BURNS AND ROE, INC.  
WPPSS  
NUCLEAR PROJECT  
NO. 2

PROJECT  
ENGINEERING  
DIRECTIVE

SUBJECT: Sac. Shield Wall Welds

REPAIR PROCEDURE FOR NCR #05688 AT THE  
541'-5" LEVEL IN REACTOR CONTAINMENT VESSEL

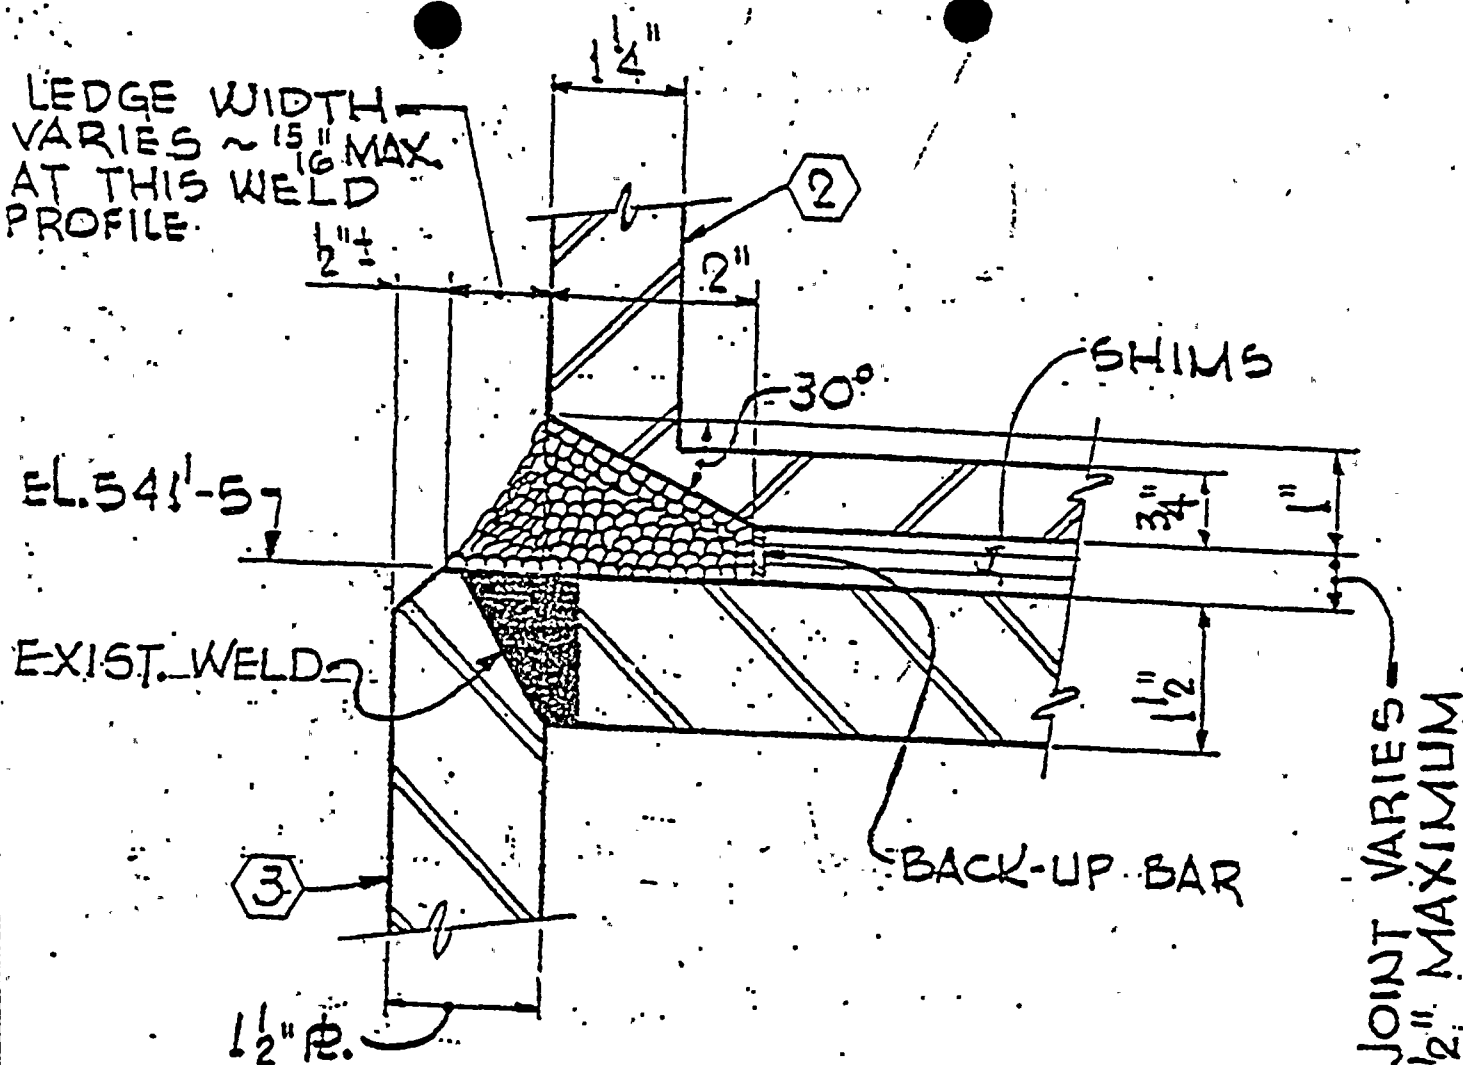
Slot welds required per detail D 2038 (\$782) made to top of shims and do not connect ring 3 (Beam type 3) and ring 4 (Beam type 2) as required.

Replace slot welds with a partial penetration weld between the upper and lower rings as shown on attached details with FCAW process being used for complete joint welding except for buttering that is required with SMAW E7018.

TYPICAL PHASE II WELD DEPOSIT  
WHERE LEDGE IS A MINIMUM OF 1" WIDE &  
SIDE R./BUILT-UP MEMBER (3) IS 1 1/2"

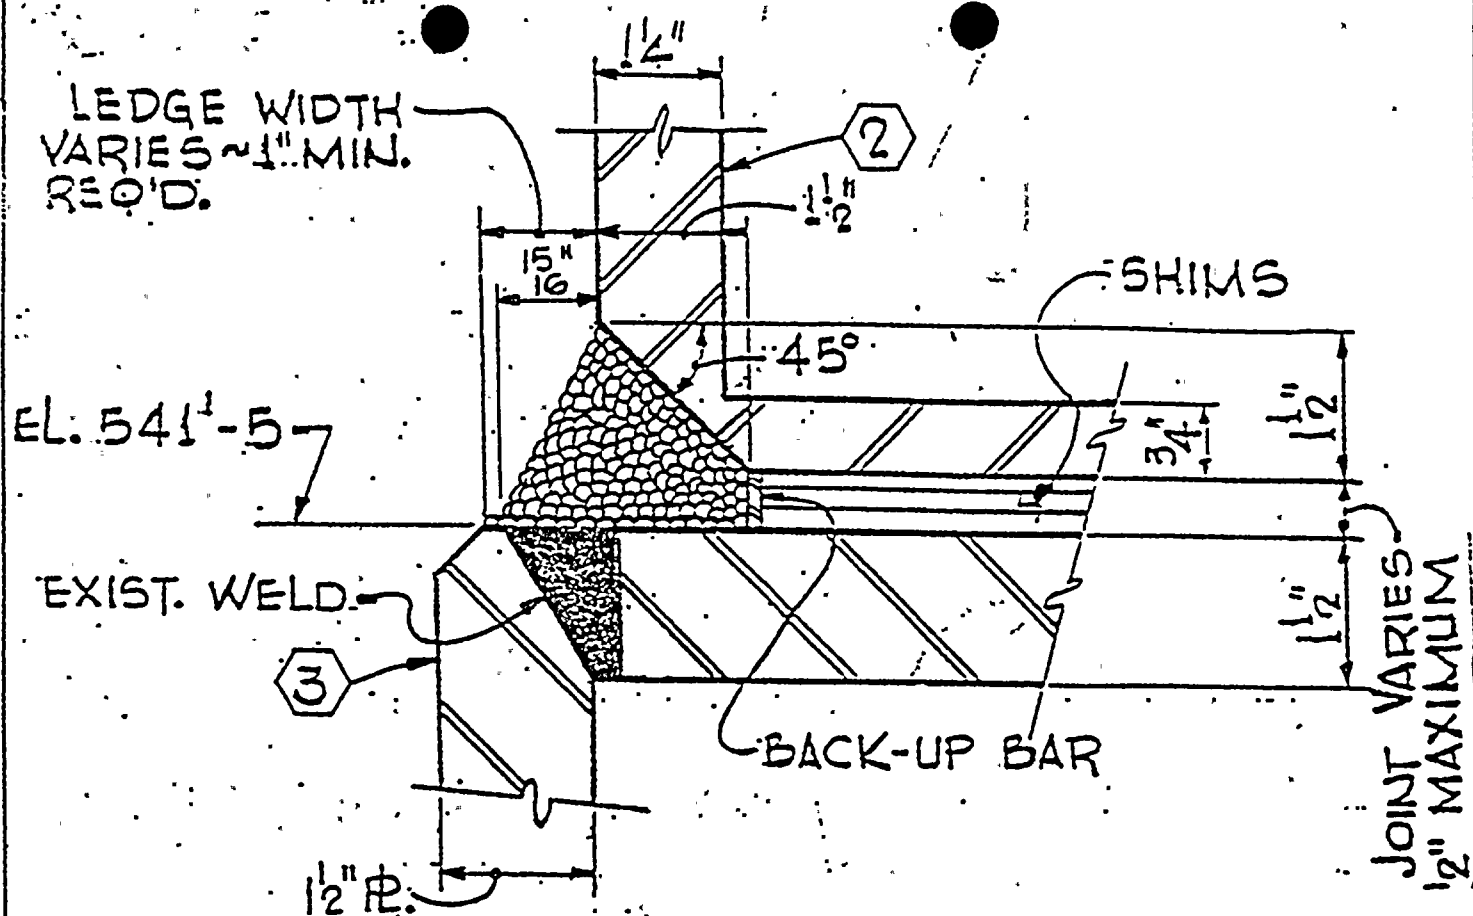
- 1) After root passes have been applied all remaining passes shall be peened. \*
- 2) M.P.T. final weld at preheat temp. and 72 hrs. after complete cool down.

# TYPICAL WELD DEPOSIT WHERE LEDGE IS LESS THAN 1" WIDE & SIDE R. / BUILT-UP MEMBER (3) IS 3"

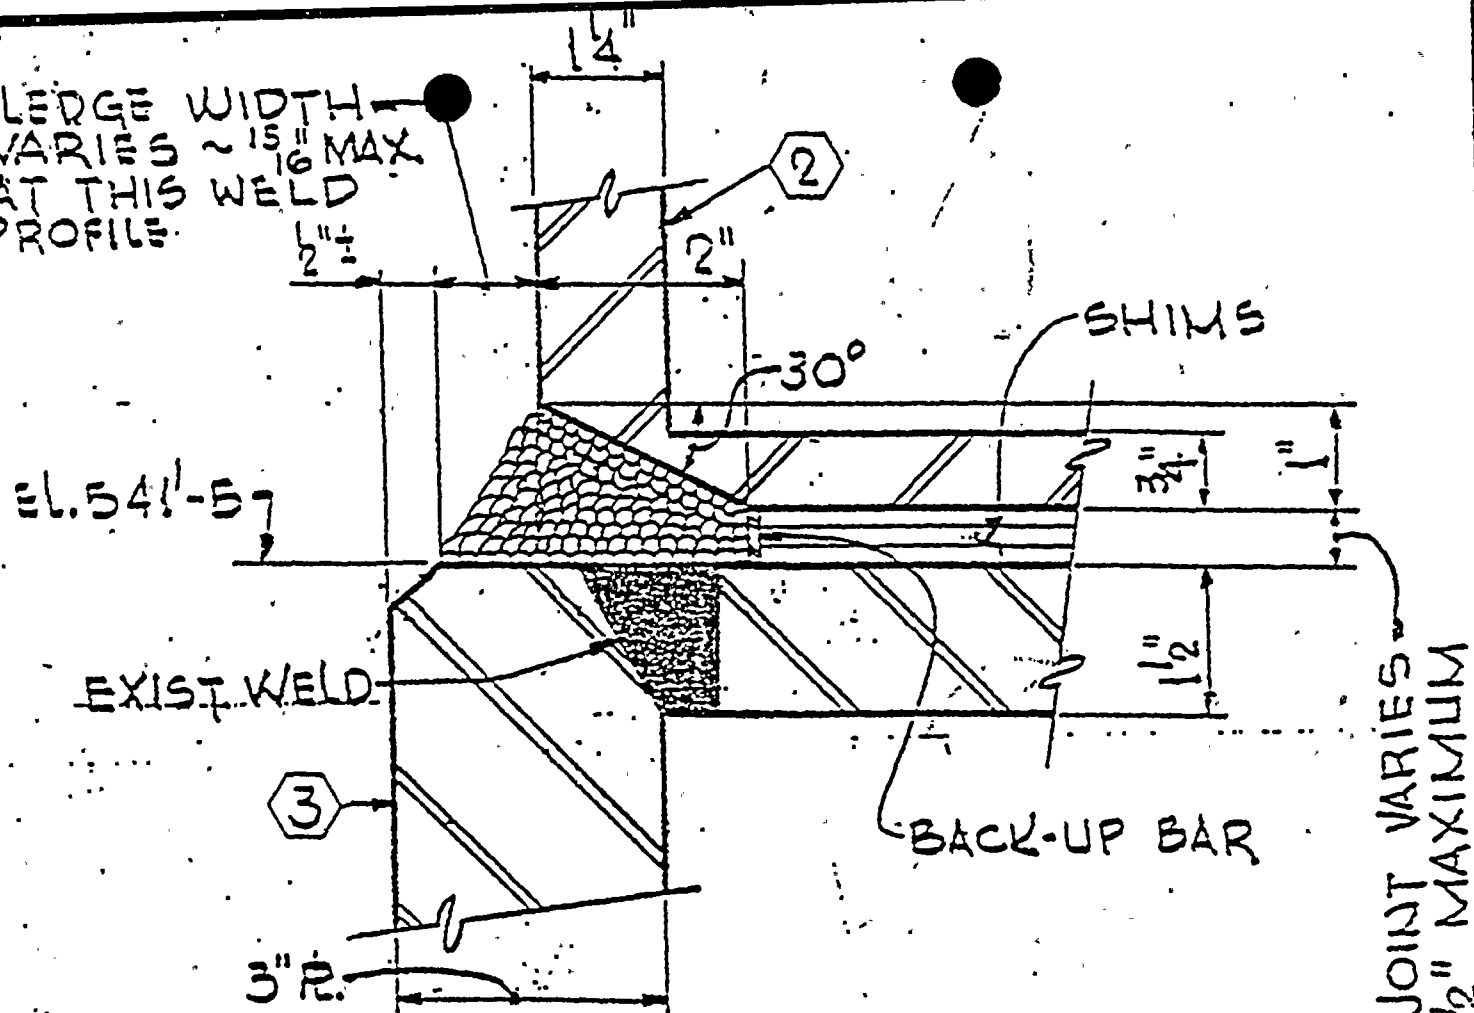
- 1) After root passes have been applied all remaining passes shall be peened. \*
- 2) M.P.T. final weld at preheat temp. and 72 hrs. after complete cool down.

SECTION A-A  
TYPICAL CASCADE WELD DETAIL

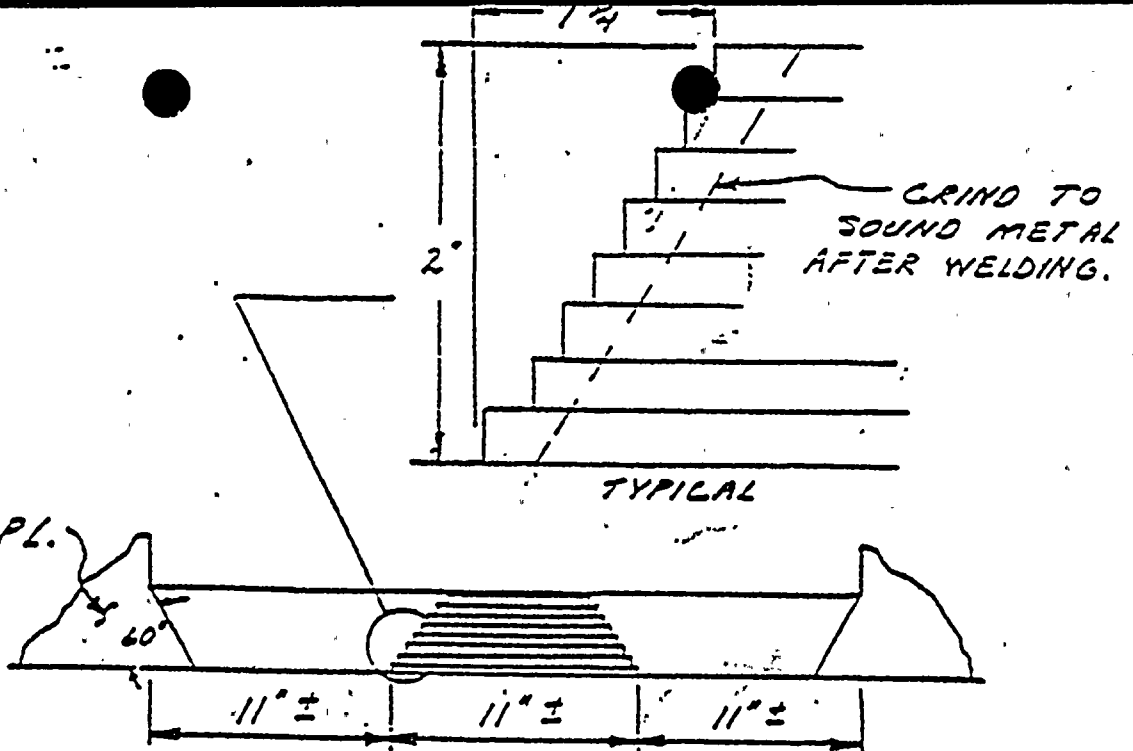
NOTES: --A) 4'-11" cascade area's shall be made first, to assure that there is no movement to the wall, also to establish the stability for the remaining welding.

B) All remaining welding may be completed in a different sequence if so designated by B & R Welding Engineer.

- 1) Four (4) welders to weld simultaneously throughout sequence.
- 2) First sequence to start at AZ. 7°-30'.
- 3) Second sequence to start at AZ 191°-30'.
- 4) Third sequence to start at AZ. 103°-30'.
- 5) No welder shall proceed ahead of any other welder in a sequence.
- 6) Each sequence number consists of approximately 11".

## PLAN ~ WELD SEQUENCE

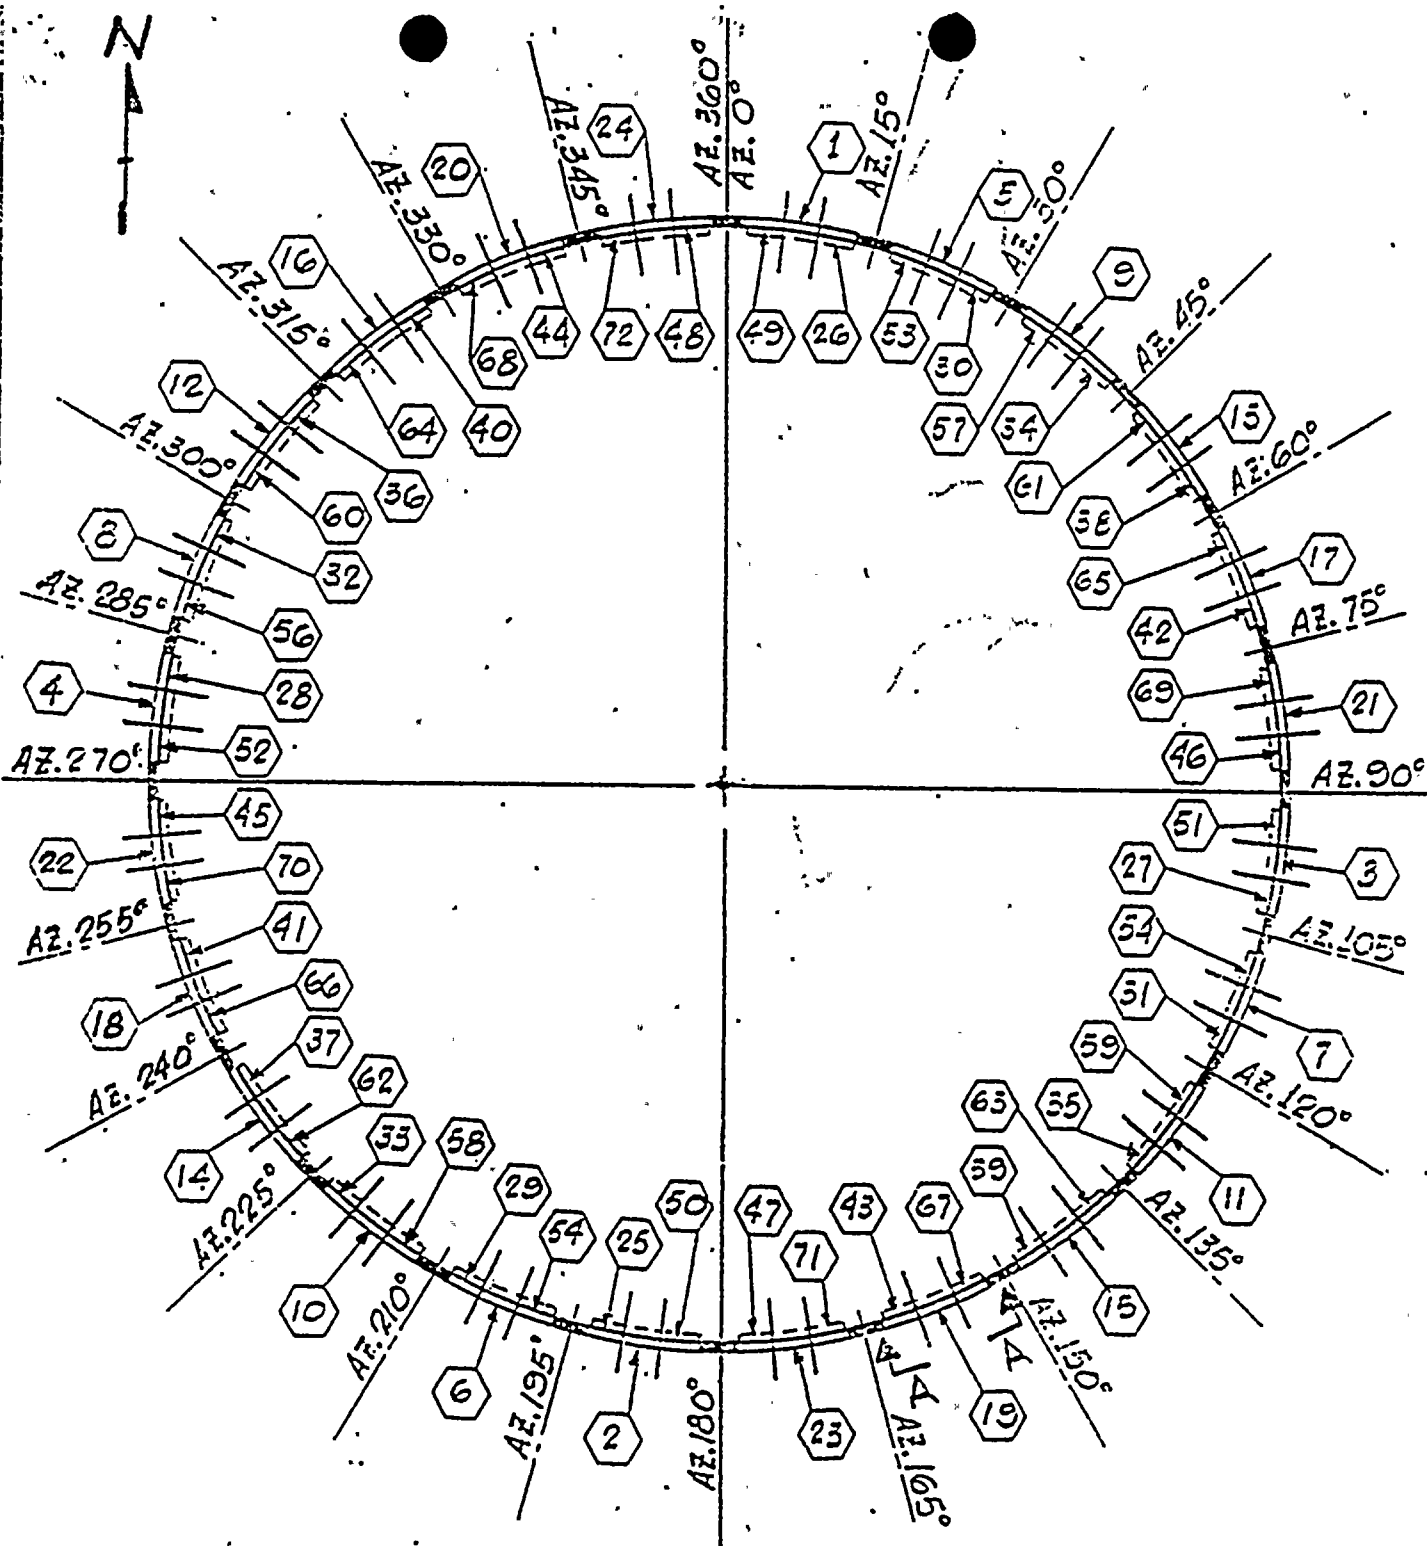
WORK THIS SHEET WITH SHEET 8th of 15
